PRODUCT CHANGE NOTIFICATION

#PCN-DC-PIC7-13

Business Unit	Product Line Code	Type of Change	Action	Date of issue
DC	AAB	Mechanical	Notify Distributors and Field	3/22/2013

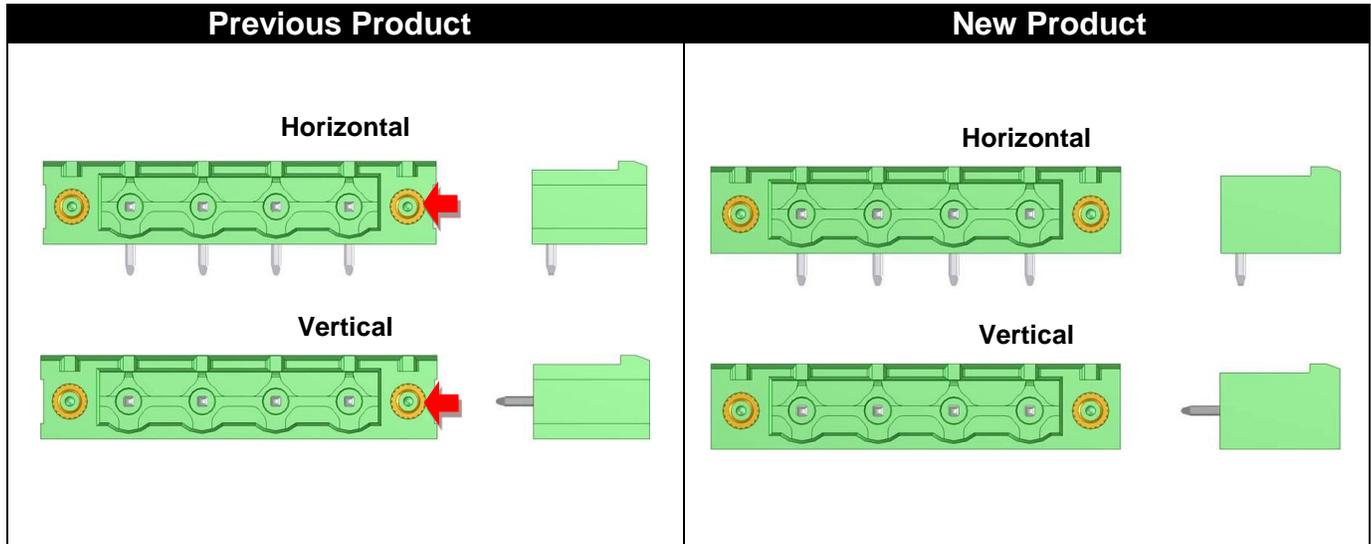
We removed the slots (see arrows) on the end walls of the headers. Now a printing (e.g. "HC") on the end walls is possible and the flange geometry is the same as the other pitches. Any further technical data and outside dimensions are not affected by this change. Depending on the inventory and number of positions, both versions will be delivered in parallel during the conversion phase.
